MV- Dock Winch Bid
ADDENDUM 1

12/21/2022

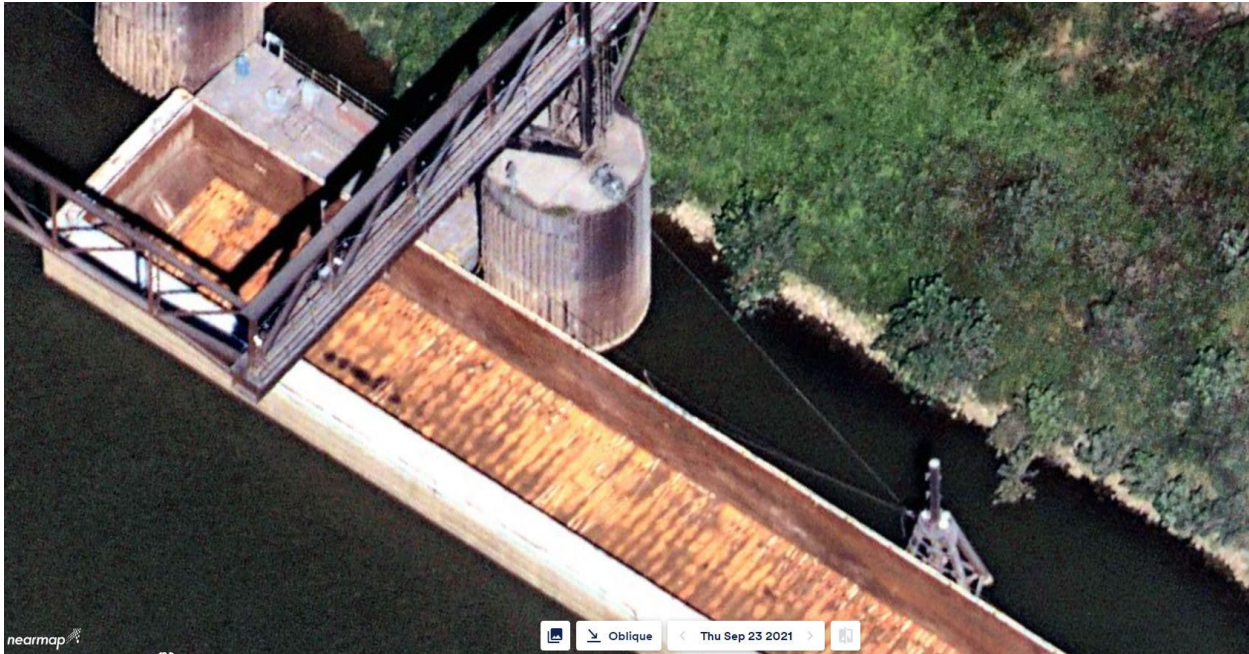
3. Where will the VFD main enclosure be located? **Former winch location was on the crane dock itself but could be placed anywhere that makes sense.**
4. It was stated winches to be installed in the same location as the previous winches. Are there any photos of the mounting location? **Nearmap images #1 & #2 are attached for reference.**

10. Will Ports of Indiana require prevailing wage rates for this work? **No.**
11. Please clarify which dolphins receive the pulleys both upstream and downstream. Also clarify which of the rings you want the pulleys mounted to. **Both upstream and downstream dolphins**

used pulleys. This is where the existing pulleys are. (NearMaps photo #1 & #2 attached for reference.)
